**KNOXVILLE/KNOX COUNTY METROPOLITAN PLANNING COMMISSION
SUBDIVISION REPORT - CONCEPT/USE ON REVIEW**

▶ **FILE #:** 8-SB-14-C
8-G-14-UR

▶ **SUBDIVISION:** THE GLEN AT HARDIN VALLEY
▶ **APPLICANT/DEVELOPER:** BENCHMARK ASSOCIATES, INC.
OWNER(S): TTBS Development, LLC

MPC FILE #s
 8-SB-14-C
 8-0-17-1-C
 7/31/2014

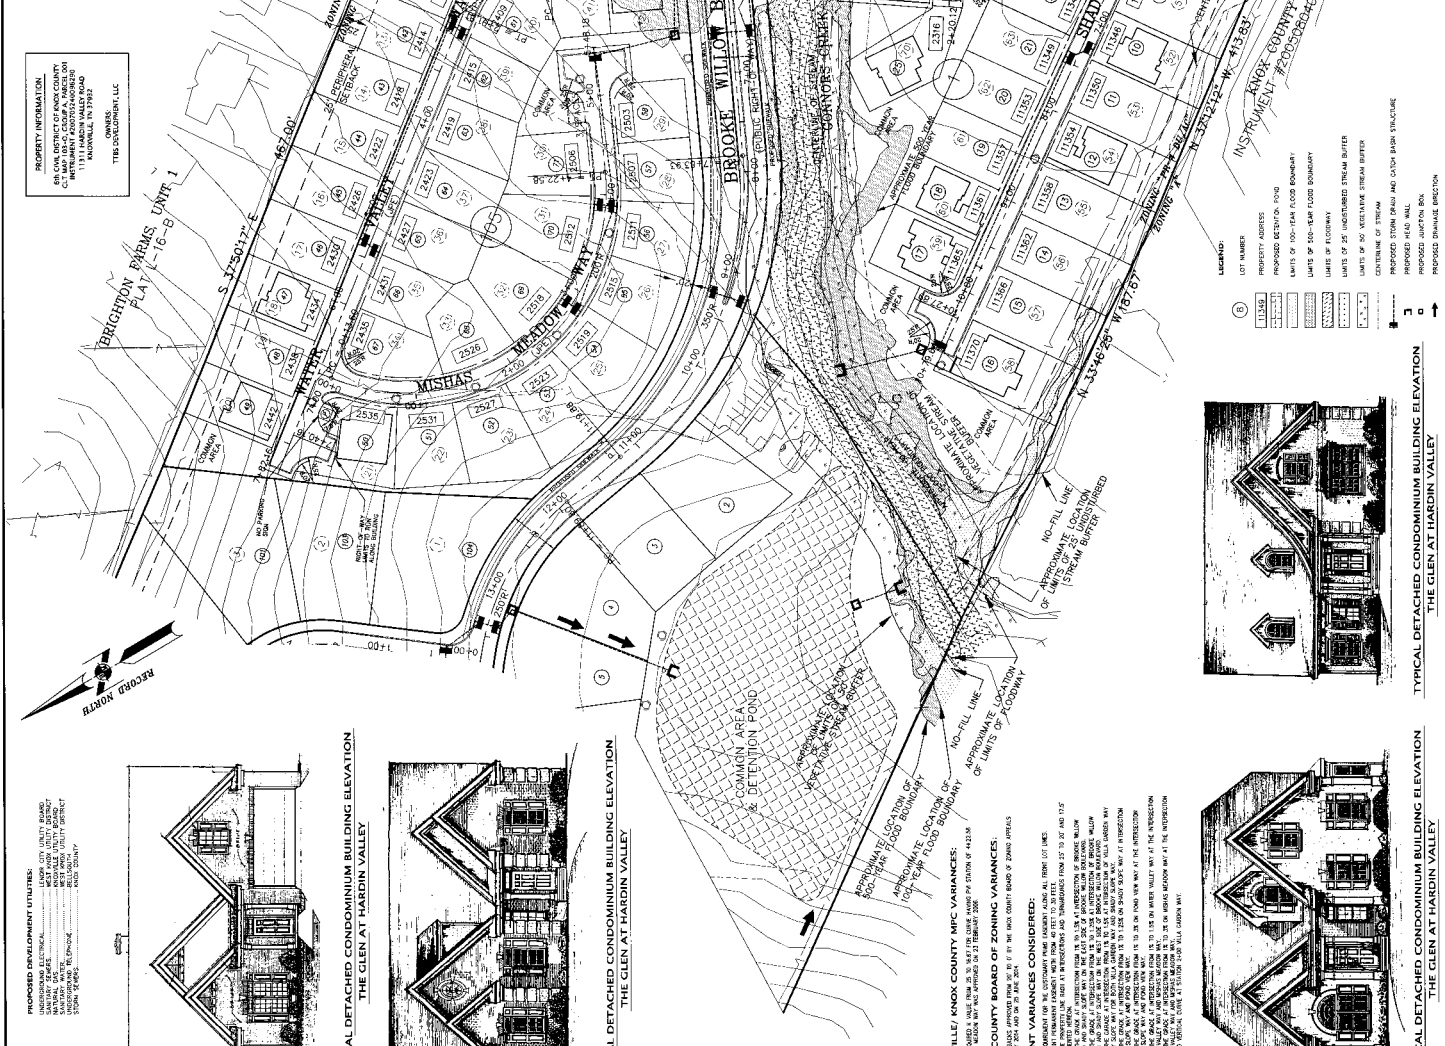
1. Standard utility and drainage easement variance from 10' along front lot lines and 5' along side lot lines to 0'.
2. Joint Permanent Easement right-of-way width variance from 40' to 30'.
3. Reduce the property line radius at intersections from 25' to 20' and 17.5' as shown
4. Require no vertical curve at sta 2+00 of Villa Garden Wy.
5. Variance of the required roadway cross section to as constructed

▶ **APPROVE** variance 1-5 because the site's topography restricts compliance with the Subdivision Regulations, and the proposed variance will not create a traffic hazard

APPROVE the Concept Plan subject to 7 conditions

1. Connection to sanitary sewer and meeting any other relevant requirements of the Knox County Health Department.
2. Meeting all applicable requirements of the Knox County Department of Engineering and Public Works.

3. Meeting all applicable requirements and obtaining all required permits from the Tenn. Dept., of Environment and Conservation
4. Implementing all recommendations of the previously prepared Traffic Impact Study for this project as may be required by the Knox County Dept. of Engineering and Public Works

5. Prior to certification of the final plat, establish a homeowners association for the purpose of assessing fees for the maintenance of the common area and any other commonly held assets.

6. Provision of sight distance easements across lots as may be required by the Knox County Dept. of Engineering and Public Works
7. A final plat application based on this concept plan will not be accepted for review by the MPC until certification of design plan approval has been submitted to the MPC staff.
